**TENTATIVE AGENDA
DECEMBER 10, 2025 6:00 P.M.
ARCHITECTURAL REVIEW BOARD**

City of Glendale - Review of Plans

Project: **808 Hawbrook Road**

Purpose of Review: To check if items #1-4 & 6 in the project's Application for Architectural Review Board have been complete, and provide additional comments/checks regarding the project's compliance with Section 4 of the ARB Guidelines, relevant ordinances of the City of Glendale, and general best practices for stormwater management.

SHEET IDENTIFICATION

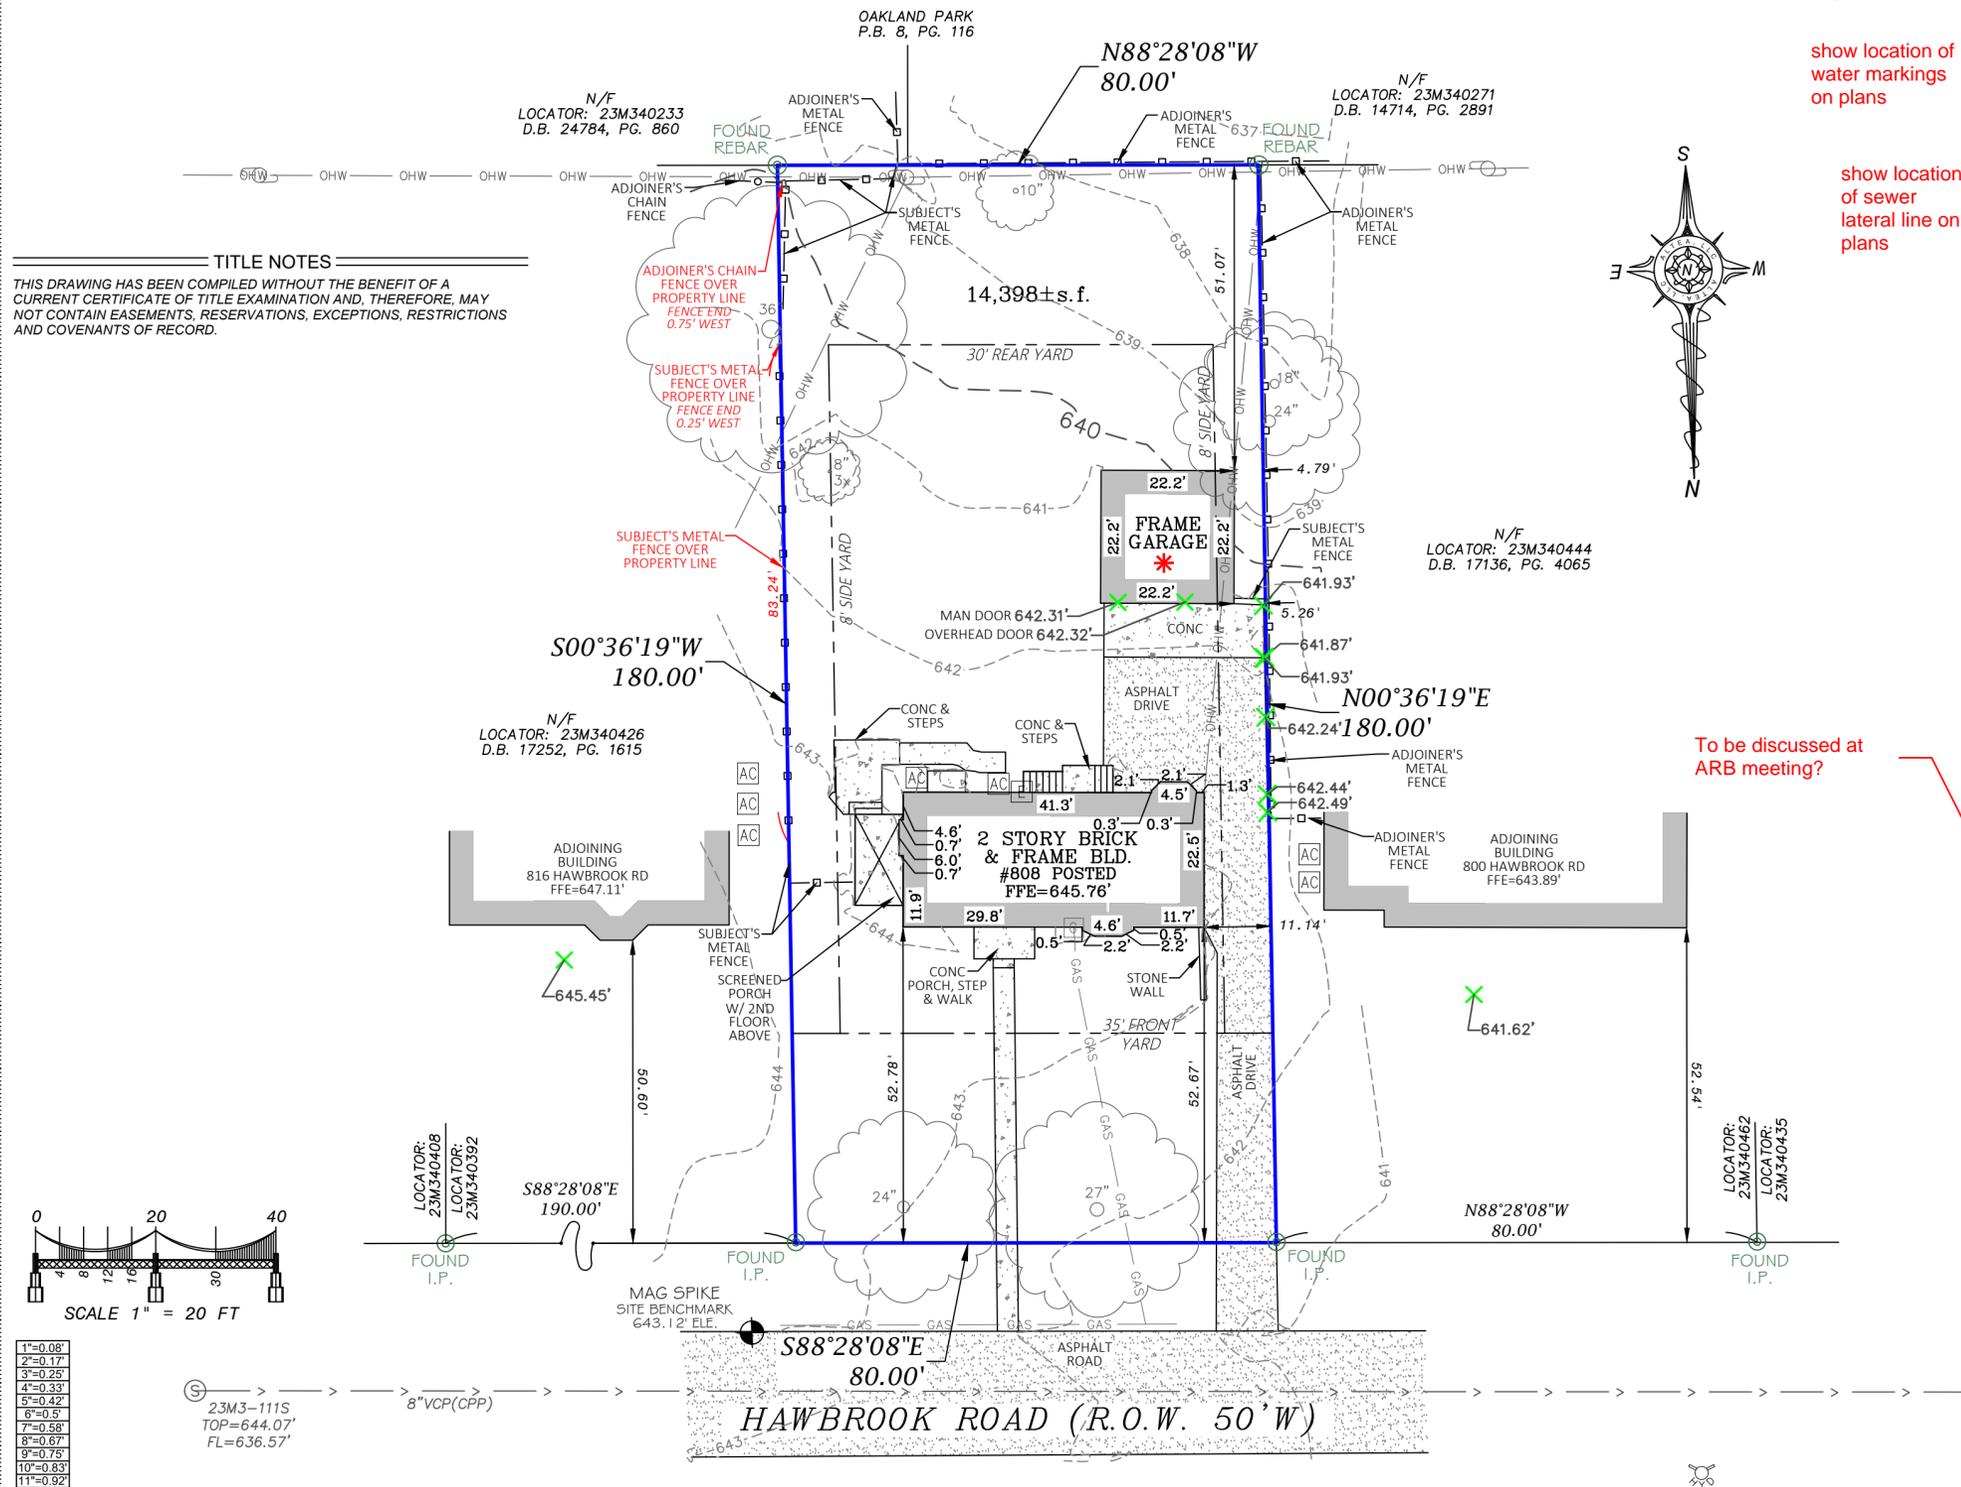
show location of ATT lines on plans if not on OHW

show location of water markings on plans

show location of sewer lateral line on plans

PROPOSED SITE PLAN

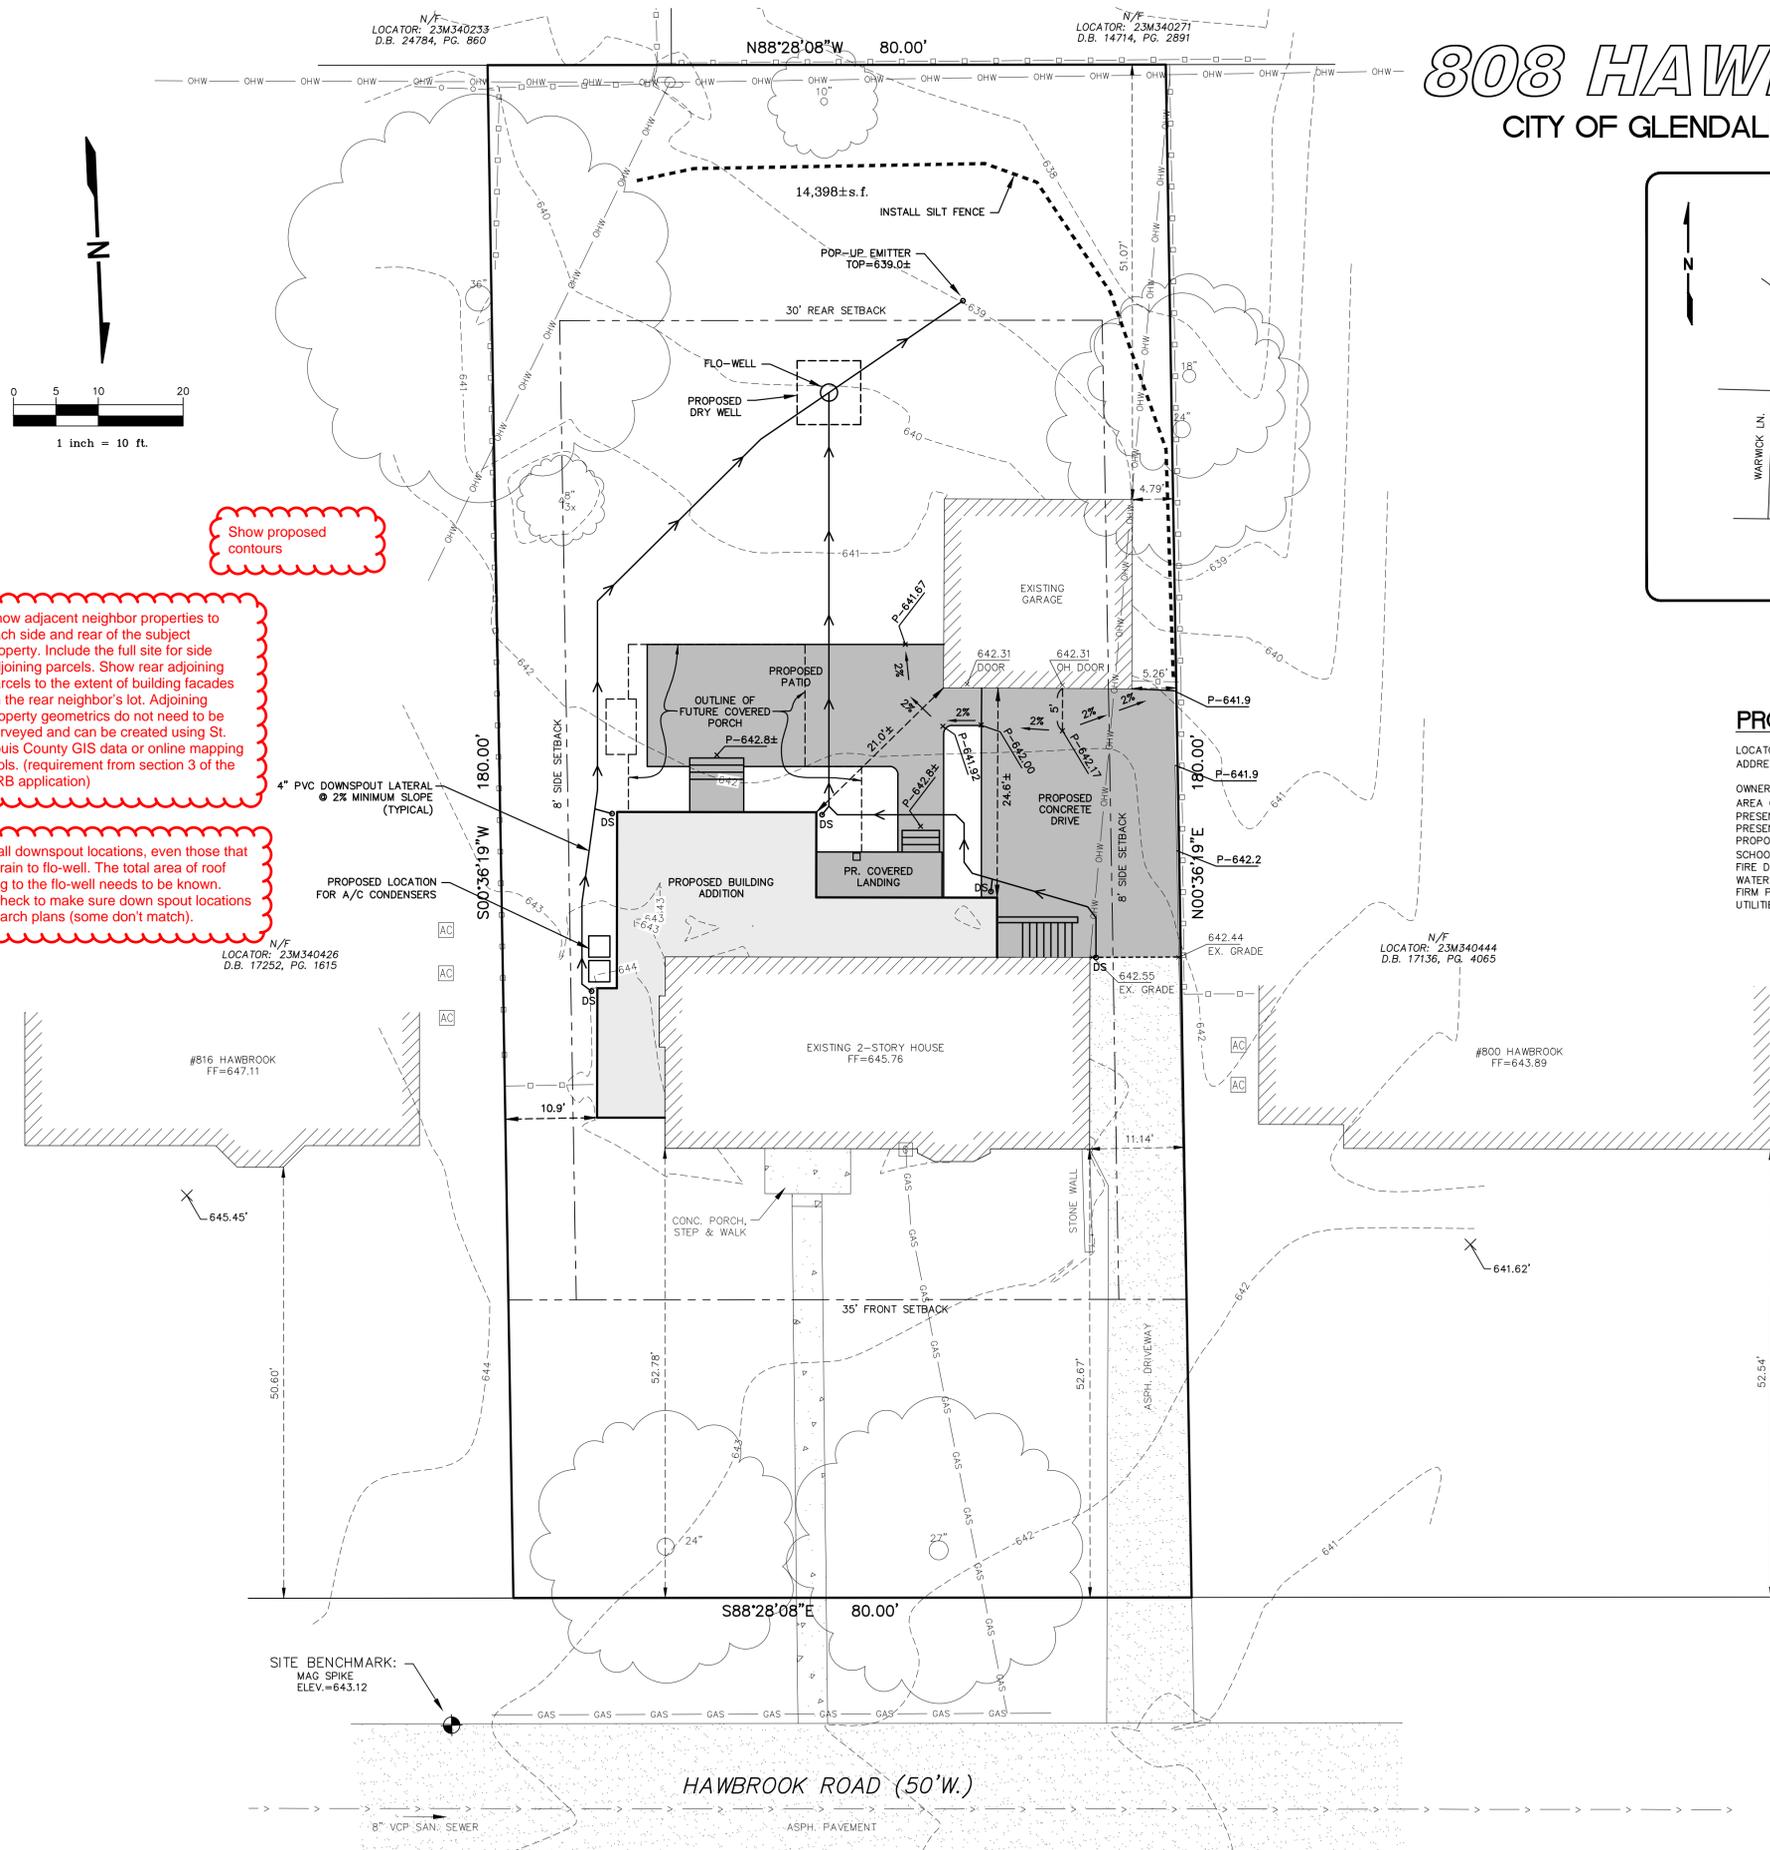
Show proposed contours

Show adjacent neighbor properties to each side and rear of the subject property. Include the full site for side adjoining parcels. Show rear adjoining parcels to the extent of building facades on the rear neighbor's lot. Adjoining property geometrics do not need to be surveyed and can be created using St. Louis County GIS data or online mapping tools. (requirement from section 3 of the ARB application)

Show all downspout locations, even those that don't drain to flo-well. The total area of roof draining to the flo-well needs to be known. Also, check to make sure down spout locations match arch plans (some don't match).
